Subject: Response to Public Comments Received on Remedial Investigation
Report and Cleanup Plan

Alliance 51st Street
eFACTS PF No. 855927
eFACTS Activity No. 60376
1646 South 51st Street
City and County of Philadelphia

**Subject: Summary Analysis of Groundwater Modeling
(Arcadis – Remedial Investigation – 1630-1640 51st Street)**

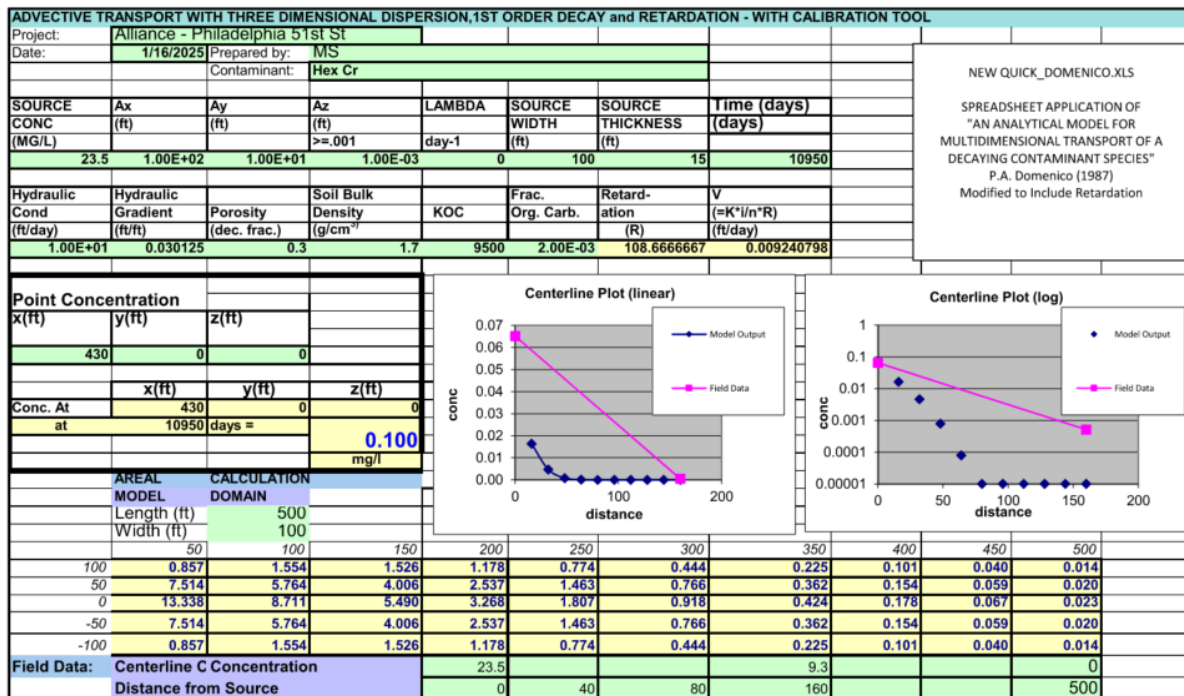
While Arcadis predicts how far the chemicals can travel east, it does not account for movement to the north or south.

That's important because field data and QD model predictions show the contamination also spreads north and south, especially for hexavalent chromium, in addition to its eastward movement.

Arcadis' assumption of one-directional flow along the groundwater path is helpful for showing general reach but may underestimate the true width of the contamination plume.

Although the model used by Arcadis includes the ability to show how contamination spreads in all directions, the report only explains how it moves to the east, in the same direction groundwater flows. This means it doesn't fully explain that the contamination also spreads to the north and south, even though both the model and actual testing data show that it does. Focusing only on eastward movement leaves out important information about how wide the plume really is. To fully understand the situation and protect nearby areas like Bartram's Garden, both the model results and the actual sampling data need to be looked at together when making cleanup decisions.

Response to Bartram's Garden Comment 1: The figures in the report related to fate and transport modeling are general schematics to simplify the interpretation of the model results. Groundwater beneath the Site and Bartram's Garden historically discharged eastward to the river, including when historic fill was placed in the area. People walking on the trails or visiting Bartram's Garden are not expected to contact groundwater as it is several feet below the ground surface. Groundwater is not used for potable purposes in the area and all residents and businesses are connected to public water supply. Future groundwater movement is not expected to require monitoring upon PADEP's acceptance of the Report and the modeling presented in the report, as well as the Final Report for the Site. See also Response to Bartram Garden's Comment 2.

A plume map was generated using Arcadis' fate and transport data.

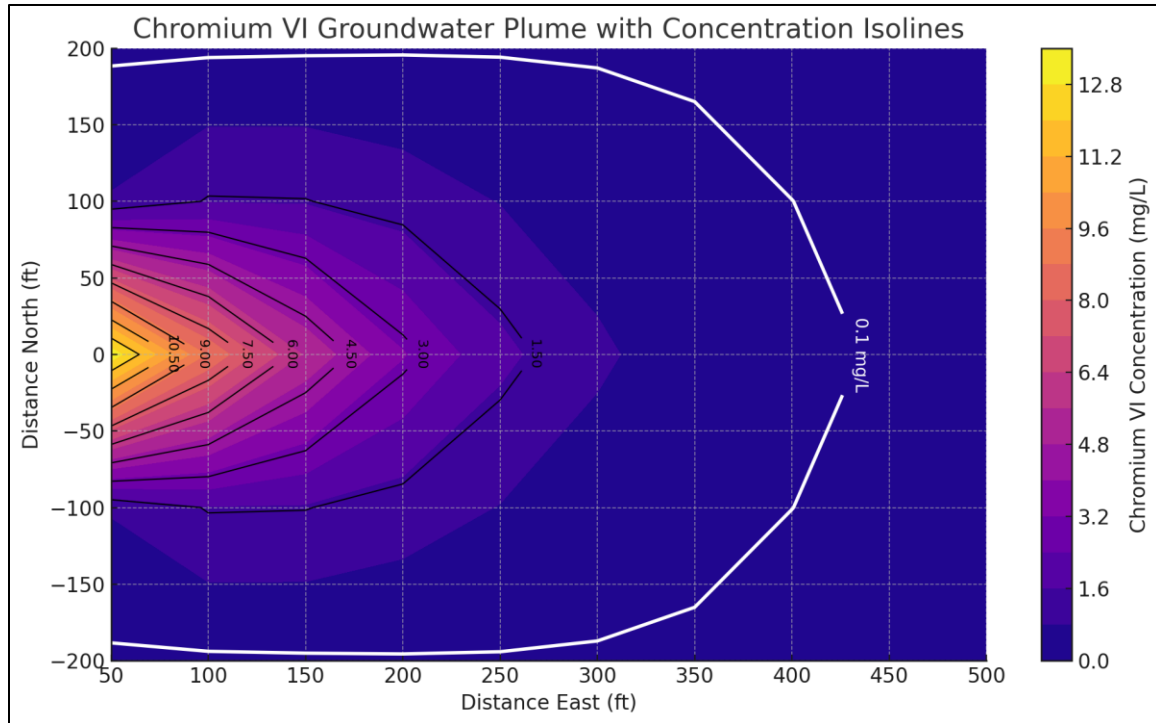
The data shows a source concentration of 23.5 mg/L at MW-4, and a predicted centered concentration of 13.3 mg/L 50 feet east of MW-4. From this point, the plume spreads:

- About 200 feet to the north
- About 200 feet to the south
- Roughly 430 feet to the east

The shape of the plume is oval and symmetrical, not just flowing east—it fans out both north and south as well.

The above plume graphic with labeled isolines (contour lines) showing the predicted Chromium VI concentrations in mg/L. The white line marks the 0.1 mg/L PADEP threshold, while the black isolines provide a clear view of predicted concentration gradients across the site.
